Objections and comments on the planning application at 84-90 Lordship Lane London Se22 8HF. Reference 14/AP/0280.

Report written by [REDACTED]

1.00 Introduction.

DW	AS	02/04/2012	1:250 @ A4	14682-AR-11.1	E
----	----	------------	------------	---------------	---

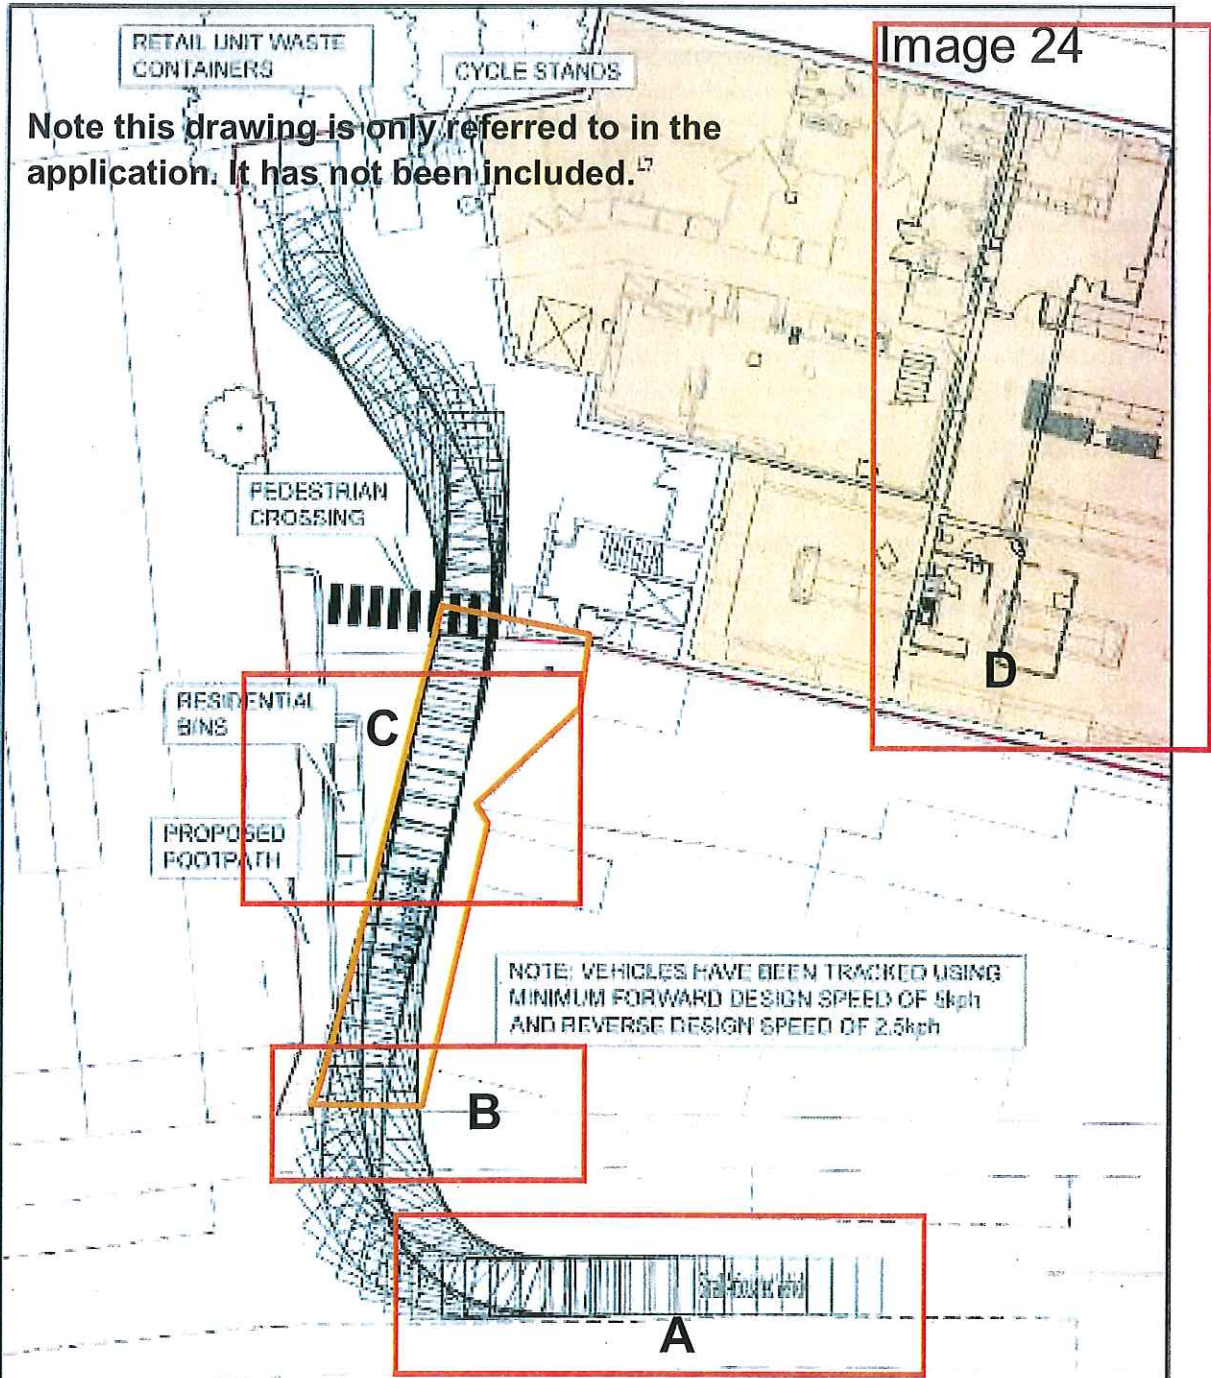
8.03. Image 24 page 27, comments on Drawing 14682-AR-11.1 Rev E. Item A to get into the site the lorry has to positioned itself on the line parked cars. There appears to be very little room for error, and would expect car to be hit on regular basis. If van parked there it would be impossible for the lorry to make it in one manoeuvre. Item B the lorry has mount the pavement to gain access, this is dangerous to any pedestrians , and is illegal. The large bollard protection to 94 has been removed to ease the restricted access. It appears from this swept path that vehicle will hit the corner of this property. Building need to be protected is requirement of the Act. Item C no protection provided to residents using refuse area. The ownership boundary is in correct on this drawing. There is very little room to accommodate a resident with push and children who exit from the flats before they find themselves in the service road. There is nothing to prevent a child from running out from the entrance straight into an on coming vehicles, the design of this area is unsafe. Item D the drawing also show the existing ground floor plan on top of the proposed, this need to be removed.

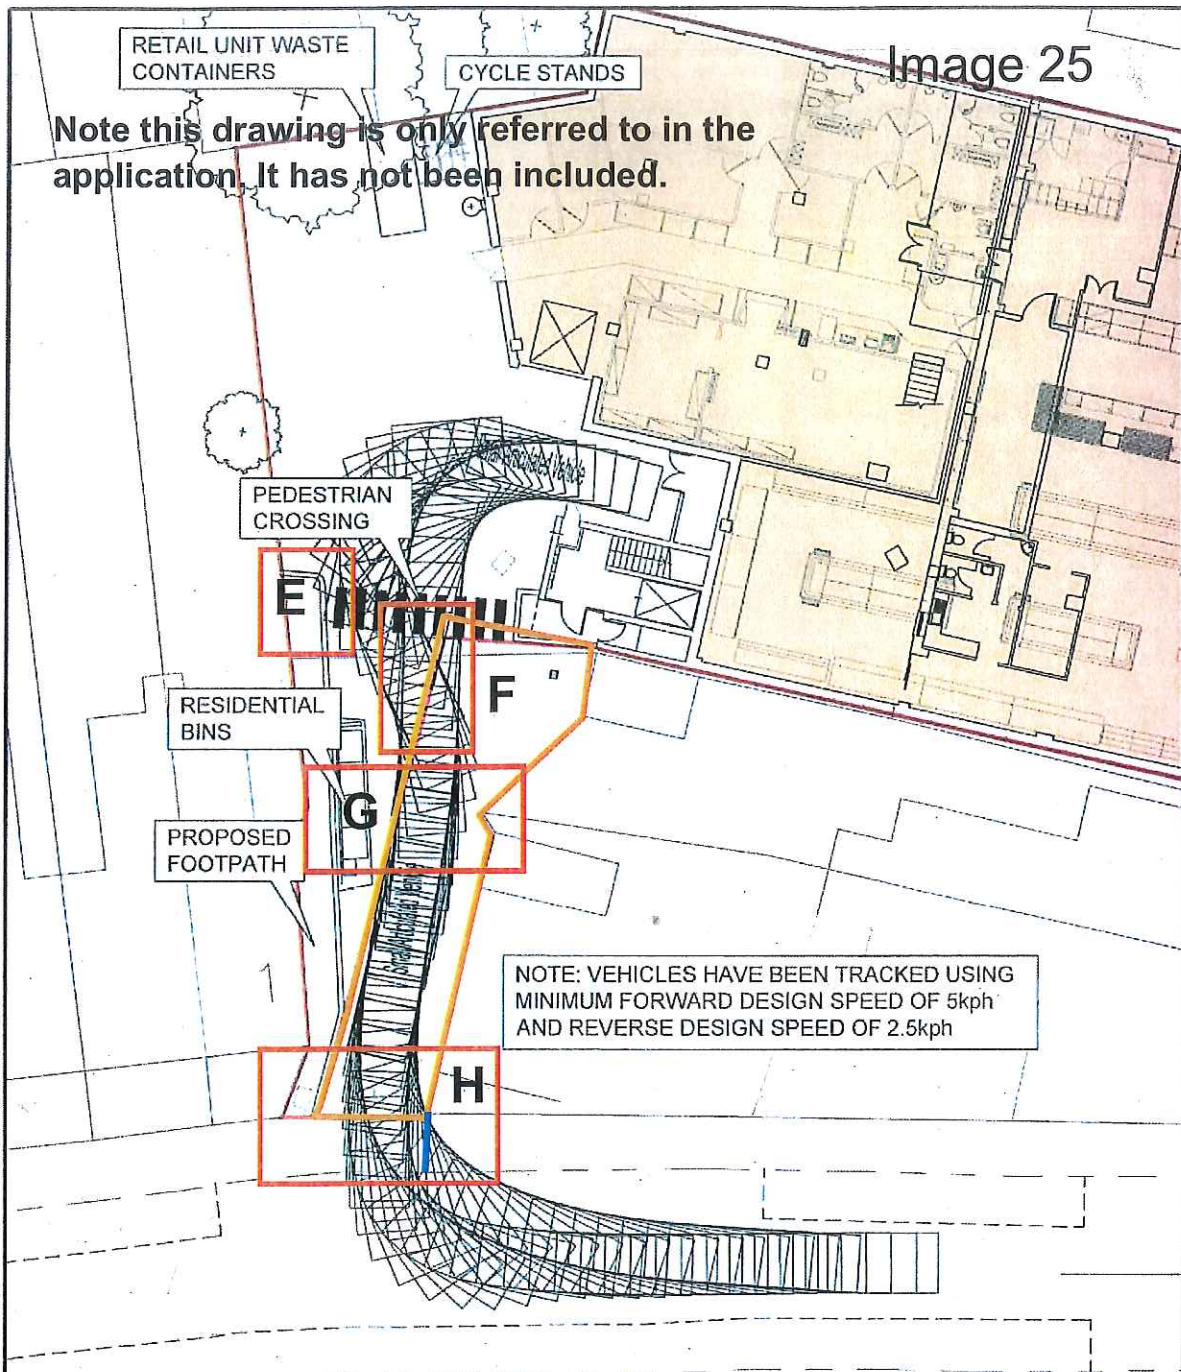
8.04. Image 25 page 28, comments on Drawing 14682-AR-11.3 Rev E. Item E, it appears that the rear trailer will go over the pedestrian route. It is clear from this drawing that there is insufficient space in the service yard to carry out this manoeuvre. Item F, the ownership boundary is in correct on this drawing. Note the crossing was moved north on drawing 1121/P(- -)110 P03 , and this has reduced the space further for a vehicle and will add to risk of hitting a residents approaching the flat entrance. The brown tinted line shows the access rights that the applicant has, and the vehicle leaving the site does not adhere to this, see section 3. Item G no protection provided to residents using refuse area, more space required by the vehicle when it leaves. Item H, when the vehicle leaves it appears to hit the corner of the property of 94, and then mounts the pavement again, the blue line marks the kerb line.

Note this drawing is only referred to in the application. It has not been included.

Chesterfield Grove				M&S	
Service vehicle swept paths 7.5t Box Van - Out				SBA part of the WYG group 100 St. John Street London EC1M 4EH t: 020 7550 5811 f: 020 7580 8518 e: sba@sba.co.uk	
DRAWN:	CHECKED:	DATE:	SCALE:	DRAWING NUMBER	REVISION:
DW	AS	02.04.2012	1:250 @ A4	14682-AR-12.2	D

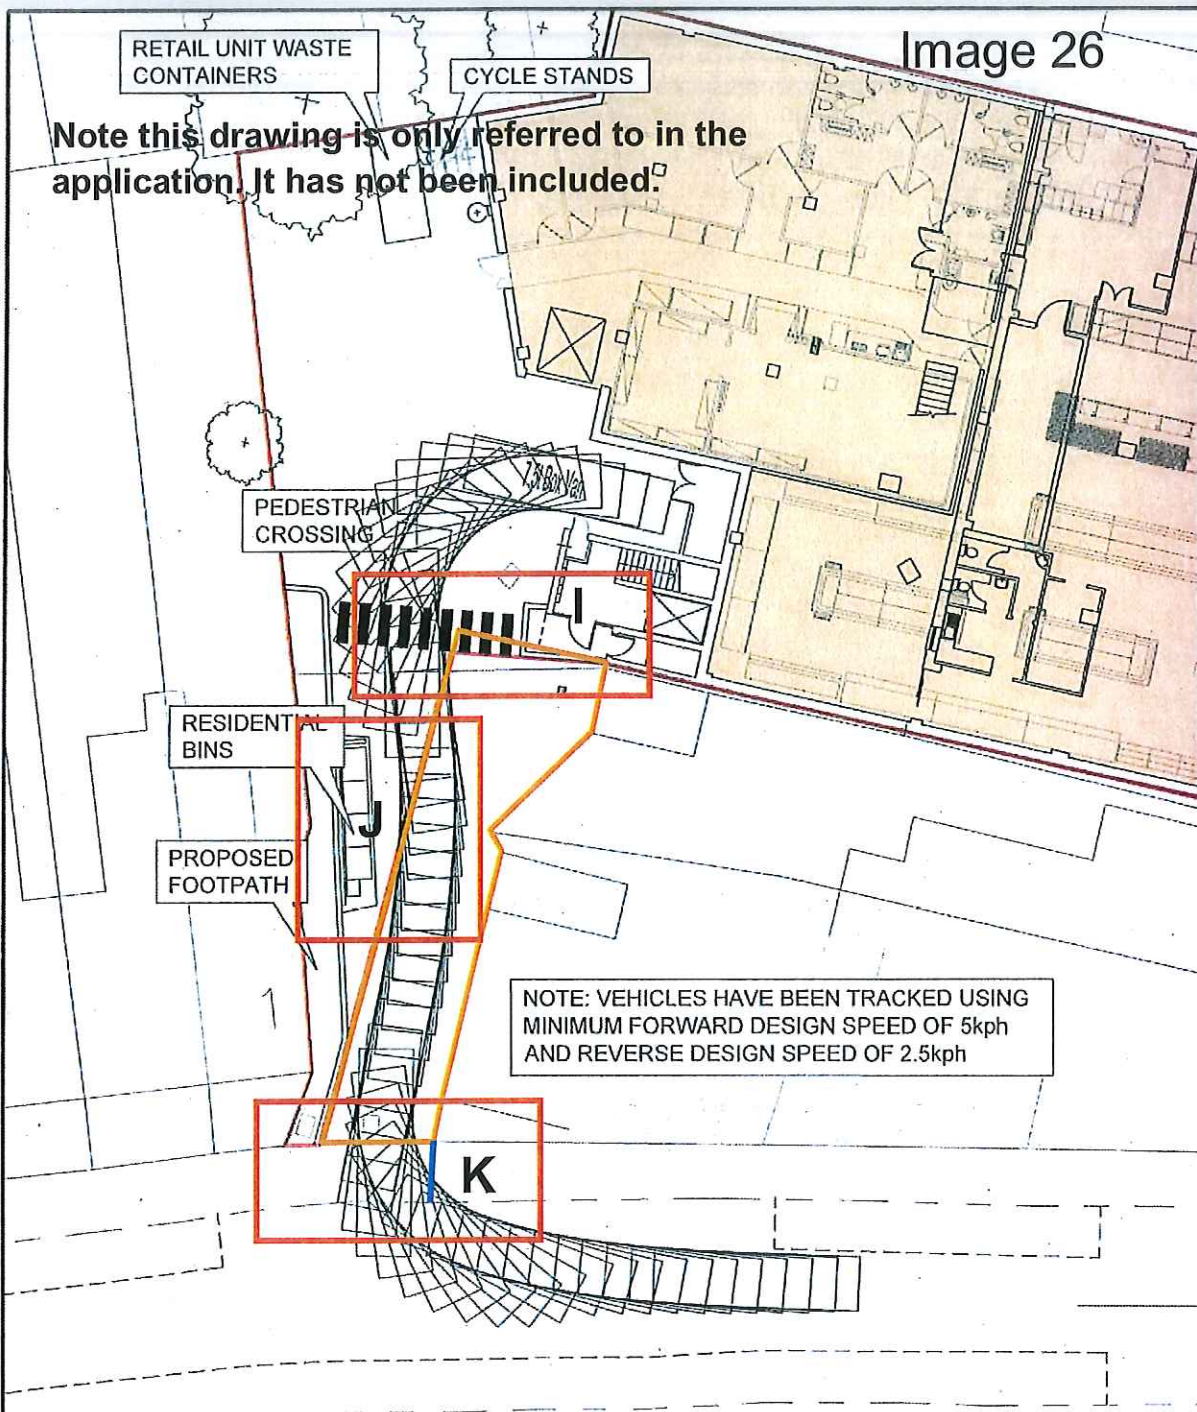
8.05. Image 29 page 29, comments on Drawing 14682-AR-12.2 Rev D a Box van leaving the site. Item I, the ownership boundary is in correct on this drawing. When the crossing is moved north onto the applicant land, there appear even less room for a box van to manoeuvre when leaving the site. It appears dangerously close to footpath used by the flat residents. It has to turn into the pedestrian crossing when leaving also dangerous manoeuvre leaving the driver unsighted to residents from the flat entrance. Item J there is even less space for residents to access the refuse bins when a box van is leaving. When protection is added a box van will find it difficult to leave the site. However that is not the real issue as the Box van is not adhering to access rights, and can only leave via the area marked by the brown tinted line. Item K the Box van also mounts the pavement when leaving, the blue line marks the kerb.

Diagram 3.

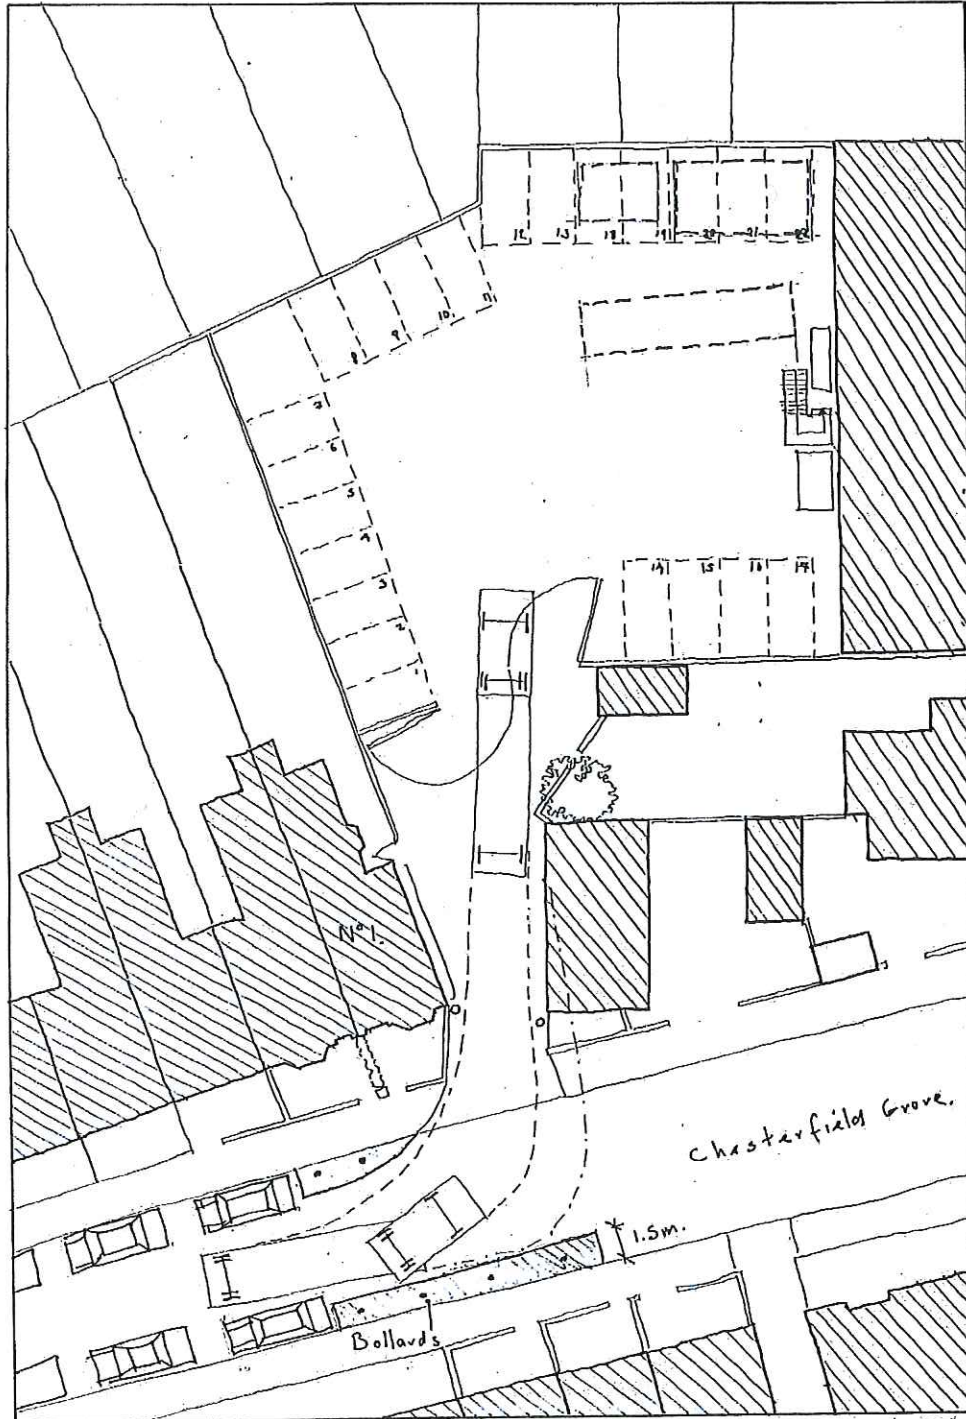
Access could be improved, by extending the pavement with bollards, to maintain clear access at all times. Note this would also provide some protection to the house south on Chesterfield Grove.
